RBG-47573

Subject: Response to Request for Additional Information on River Bend Station Recommendation
2.1 Flood Hazard Re-evaluation
River Bend Station - Unit 1
Docket No. 50-458
License No. NPF-47

**Attachment to
RBG-47573**

Response to Request for Additional Information

Figure 1: West Creek Subwatershed LIP Configuration

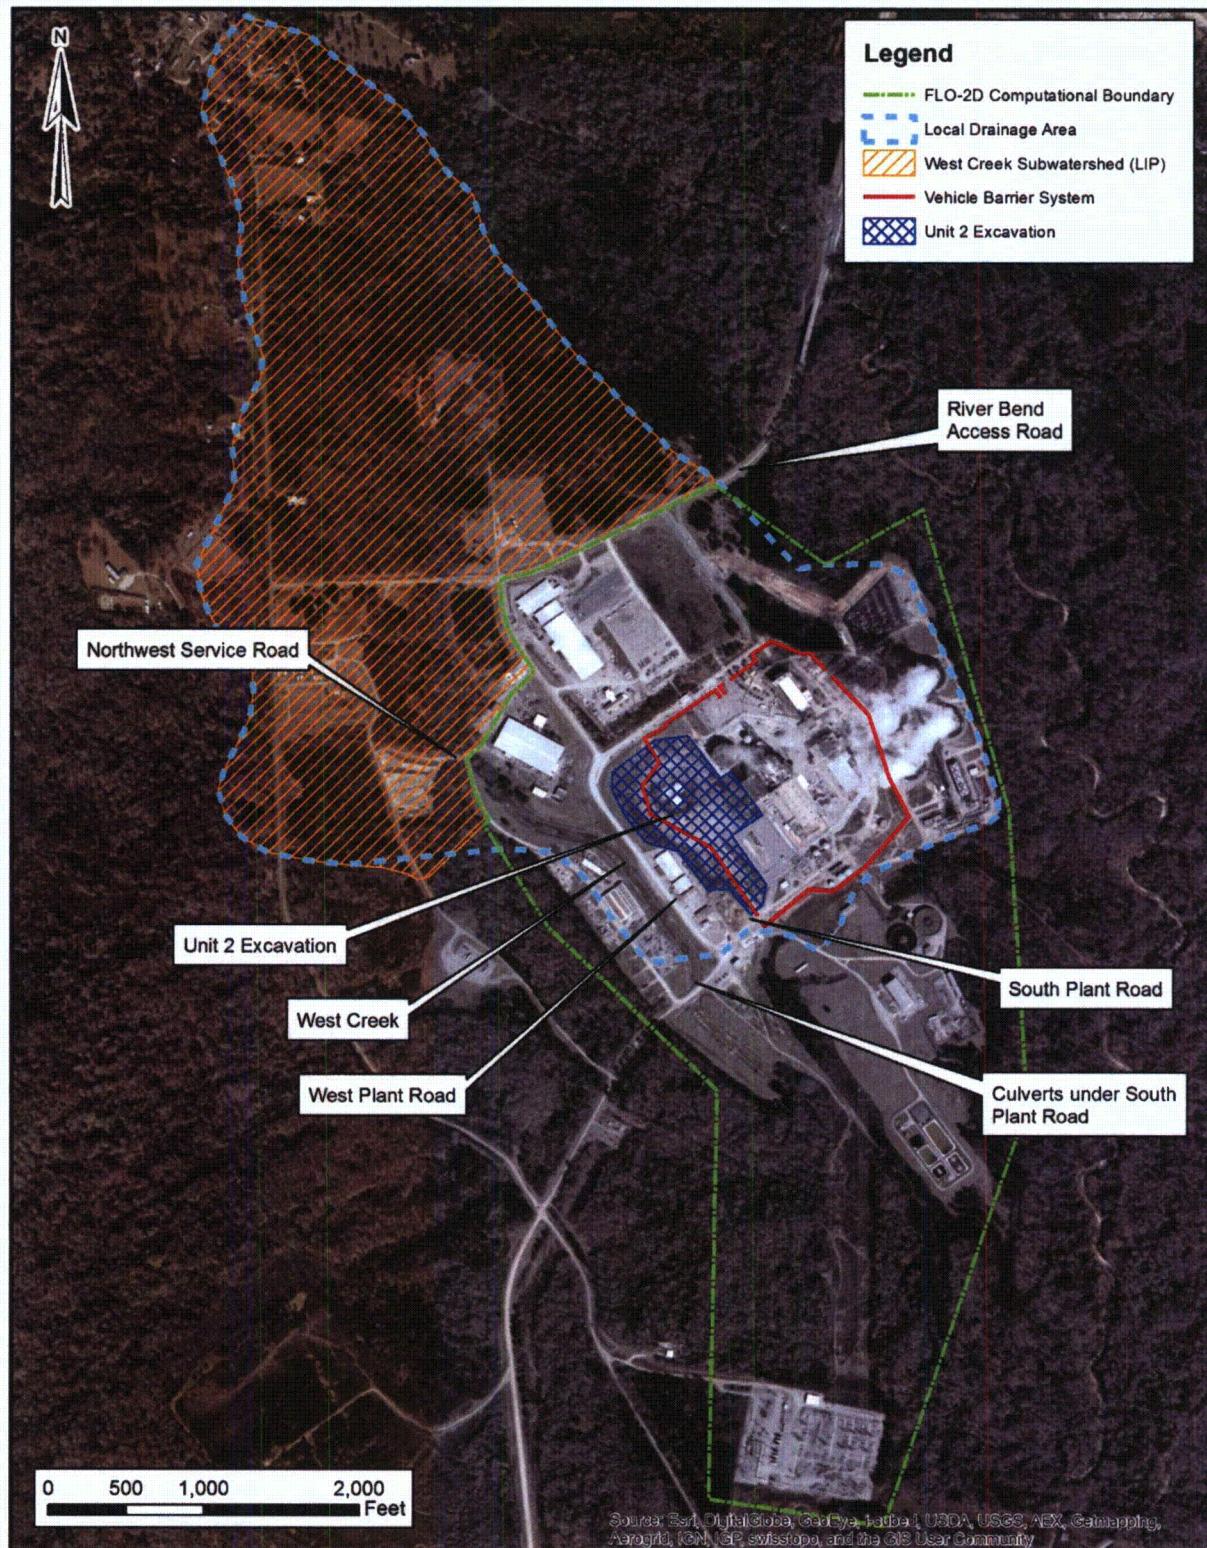
Background: Concerning the treatment of the modeled representation of West Creek in the FLO-2D model, AREVA Document No. 32-9207353-000 section 2.1.1 states that the LIP subwatershed for West Creek was delineated at a point approximately 400 ft (131m) upstream of the mouth of the channelized portion of the creek. However, the inflow hydrograph for West Creek was added to the inflow grid element directly upstream of the channelized section in FLO-2D.

Request: Discuss the conservatism of locating the West Creek inflow node at the mouth of the channelized portion of West Creek as opposed to where the inflow from the creek enters the grid system, along the computational boundary. Discuss the effect that backwater from Grants Bayou into West Creek has on the model and how conservatism is employed in the model to appropriately represent this.

The West Creek inflow node was located at the mouth of the channelized portion of West Creek to ensure that the total computed flow from the West Creek subwatershed north of the Northwest Service Road (AREVA, 2014a and AREVA, 2014b) is routed through the channelized portion of West Creek thereby maximizing the resulting water surface elevation in the channel near RBS.

Note that rainfall is simulated throughout the FLO-2D model domain and hence rain falling in the area between the computational boundary of the FLO-2D grid system where the inflow from the creek enters the FLO-2D (at the Northwest Service Road) grid system and the mouth of the channelized portion of West Creek is accounted for in the LIP analysis. See Figures 1 and 2 for the locations of the mouth of the channelized portion of West Creek and the watershed delineation point at the Northwest Service Road.

Figure 3: FLO-2D Grid Element Elevation Rendering - No ARF Simulation

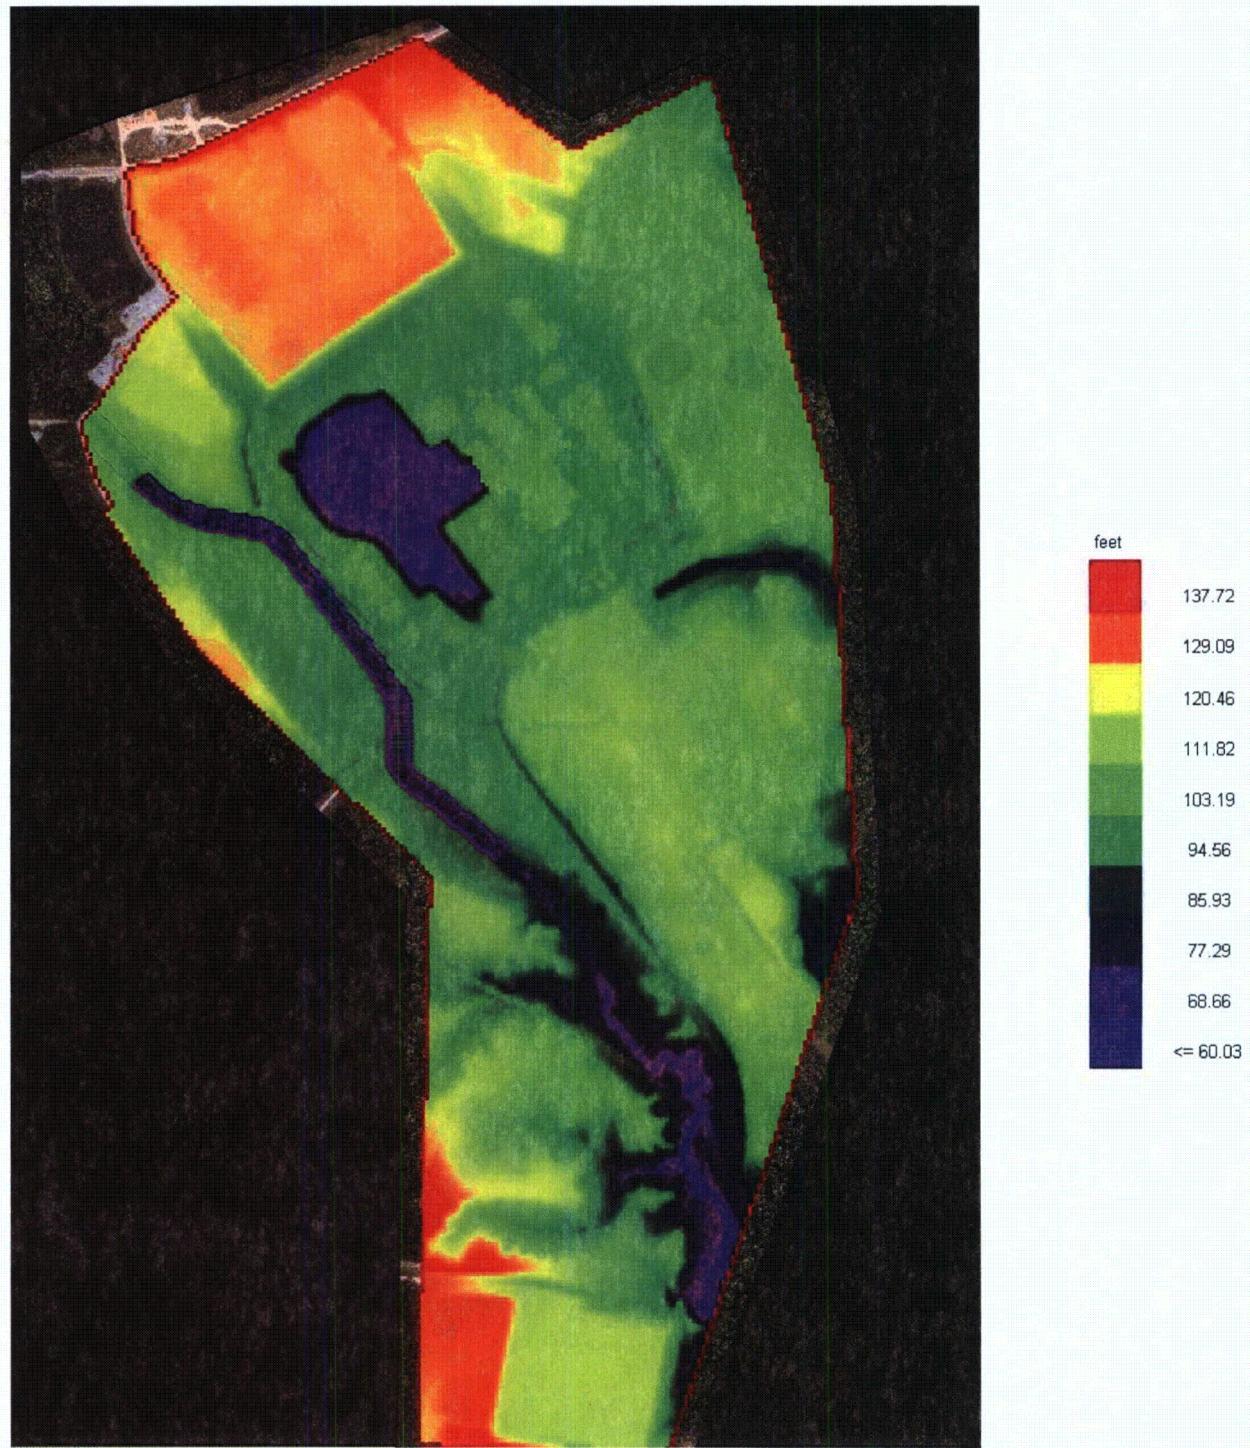
Background: Width Reduction Factors (WRFs) and Area Reduction Factors (ARFs) were assigned to grid elements representing buildings at RBS in the FLO-2D model. Grid elements that were completely within the extent of a building were blocked with WRFs and ARFs set equal to 1.0. Elements partially within the extent of a building were either completely blocked or completely open. FHRR section 3.1.2.1.2 states that FLO-2D calculates runoff from blocked grid elements and translates such runoff to the nearest unblocked grid element; however, it is not clear how and where rainfall onto the interior building elements is distributed to these unblocked grid elements. Previous staff experience has indicated discrepancies between how software documentation states that rainfall runoff is handled and how the selected model configuration produces those desired effects. Further clarification is required to ensure the selected model configuration matches physical characteristics at the site to ensure consistency, conservatism, and realism. The staff recognizes the coding issues for rainfall on roofs within FLO-2D for model builds before 2014. Before being re-coded in 2014, FLO-2D did not allow water to move outside the building perimeter.

Request: Provide a detailed description of how rainfall is routed to the nearest unblocked grid element in FLO-2D. Clarify or reanalyze how rainfall onto building roofs is physically routed at the River Bend Station and demonstrate that the model implementation accounts for roof runoff in a manner consistent with physical reality. Provide a figure showing locations of roof discharge onto the site yard. If building rainfall is routed to a concentrated discharge point, provide a discussion of how the model conservatively simulates localized flooding impacts due to concentrated discharge, and, if necessary, provide sensitivity analysis results that demonstrate the significance of localized flooding impacts from roof discharge. Describe the extent to which the model restricts building rainfall volume from entering the site yard due to the selected reduction factors (i.e., demonstrate whether there is a significant backwater effect at the building interface).

In the RBS LIP calculation (AREVA, 2014), ARFs and WRFs were used in conjunction with elevating the grid elements representing areas occupied by buildings to model buildings. A sensitivity analysis was performed by eliminating Area Reduction Factors (ARFs) and Width Reduction Factors (WRFs) to assess if the FLO-2D model implementation at RBS accounts for roof runoff realistically. Buildings at RBS were represented as elevated grid cells based on the site survey and the high resolution orthoimagery. Elevating building grid elements allows for FLO-2D to recognize those grid elements are obstructions relative to lower ground grid elements, and results in runoff from the building rooftops to the ground surface. Grid elements that were completely within the aerial extent of a building were assigned elevations at least 5 feet higher than the surrounding topography (See Figure 3). Uniform elevations were assigned to grid elements representing a single building to ensure that runoff from rooftops are uniformly distributed to the surrounding areas. The peak 1-hour duration LIP depth of 19.4 inches is less than the assumed 5 feet height of the buildings. Therefore, water will not build up high enough to result in flow over the elevated buildings. Elevating grid elements to represent buildings has the potential to create an artificially high hydraulic gradient that may decrease flow depths and increase velocities at the intersection of building grid elements and grid elements representing the adjacent grade. The use of an assumed building height of 5 feet was minimizes this potential.

A comparison of the results of the sensitivity analysis without ARF/WRFs and the results of the model implementation in the RBS LIP calculation (AREVA, 2014) are shown in Table 2: Comparison of Results with and without ARFs. The results from the model implementation in the RBS LIP calculation described in the FHRR are between 0 to 0.2 feet of the results from this sensitivity analysis. No door that was previously dry became wet (flood elevation exceeds elevation at bottom of door) based on the results from the sensitivity analysis. The results of this analysis indicate that the two methodologies for modeling rooftop precipitation drainage (using FLO-2D ARFs/WRFs and using manually elevated grid cells) are in relatively close agreement. Therefore it is demonstrated through this sensitivity analysis that water falling onto buildings in the RBS LIP calculation (AREVA, 2014) was routed as runoff onto the adjacent site grades. The FLO-2D input and output files for this sensitivity run are included as Attachment B.

Figure 4: Southeast Drainage Divides

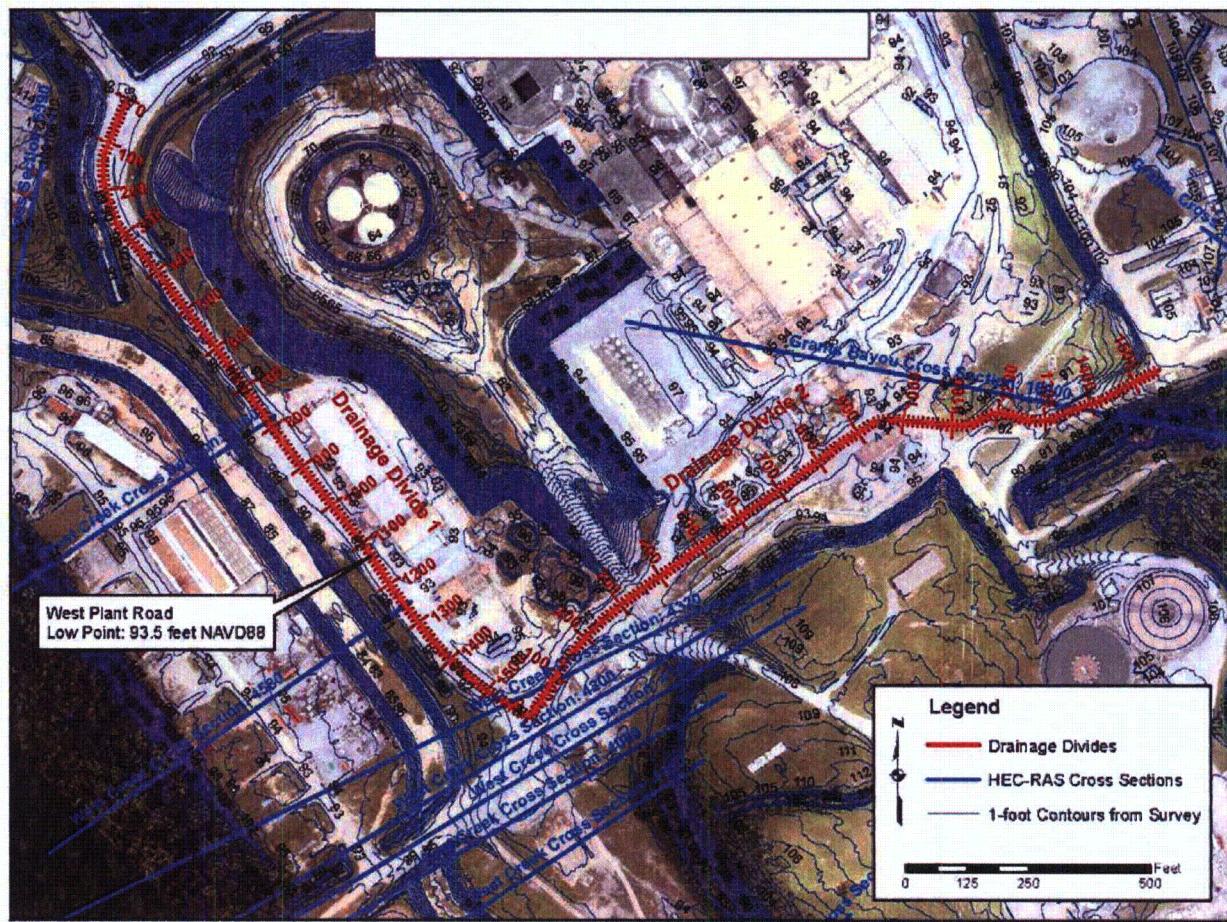
Background: *In Table 4.1-1, based on elevation alone, the Grants Bayou PMF water level would trigger inclusion in the Integrated Assessment. The text on FHRR Section 4.1.9 (page 4-5) provides partial explanation of this as a non-issue; and, the elevation of a “drainage divide” that prevents the Grants Bayou PMF from reaching the site is mentioned earlier in FHRR Section 3.2.2.2.3 (page 3-12). This elevation is discussed in a calculation package, but is needed relative to the FHRR. Also, with respect to West Creek (FHRR Section 3.2.2.3.3), “[t]he top elevation of West Plant Road [WPR] drainage divide at the lowest point is 93.5 ft NAVD88 (AREVA, 2013a).” It is not clear to staff whether this is a single point or a length of road.*

Request: *Provide delineation of site drainage divides, with pertinent elevation information, important to the reevaluation; and, where appropriate, whether each drainage divide provides a protected level in the design basis. Provide a figure to include visual reference to drainage divides mentioned in the text; and, clarify in Table 4.1-1 whether the Grants Bayou PMF, with and without wind and wave effects, is separated from the site by a drainage divide with a stated elevation or range thereof. Provide a figure showing the WPR drainage divide low point. Provide clarity to staff whether the WPR low-point this is a single point or a length of the road.*

Ground surface elevation profiles along the site drainage divides have been included as Attachment F. Low points referenced in the FHRR are called out along these drainage divides. The lowest point of West Plant Road, which is noted as 93.5 ft NAVD88, is a single point along the divide. The ground surface profile varies along West Plant Road (Drainage Divide 1) as shown in Figure F-1. The West Creek PMF overtops the divide along a distance of approximately 900 feet (Figure F-1). A map showing the drainage divide between West Creek and the RBS site is provided as Figure 4.

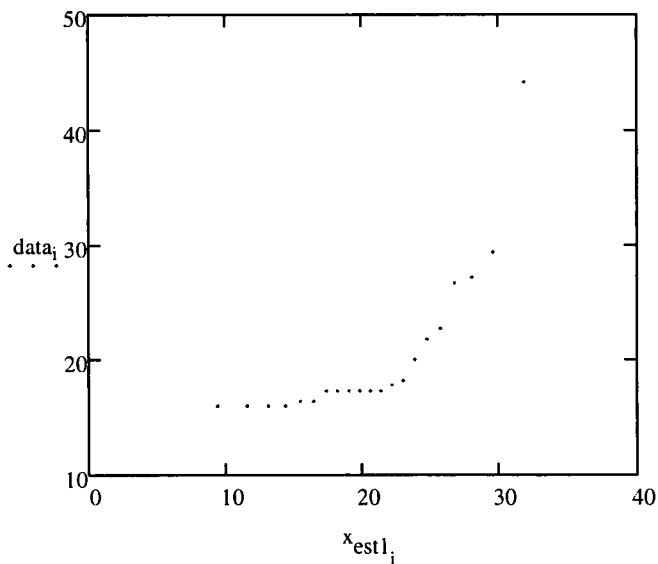
Request: Discuss the decision to apply the Gumbel Distribution to wind speed data. Compare the results from the Gumbel distribution to other widely used distributions such as the Weibull Distribution.

A comparison of the results of the 2-year wind speed calculation using the Gumbel (Maidment, 1993), Weibull (Maidment, 1993), and Log Pearson III (USGS, 1982) distributions are shown in the table below. The distribution fits were assessed by calculating the Pearson r correlation coefficient for each method. The 2-year wind speed calculated using the Weibull distribution is higher, but also a significantly worse fit. The 2-year wind speed using the Log Pearson III distribution has a better fit but yields a less conservative wind speed value. Therefore, the 2-year wind speed calculated using the Gumbel distribution represents an appropriate estimate that both fits the data well and is also conservative. MathCAD and Excel calculation sheets are presented in Attachment E.
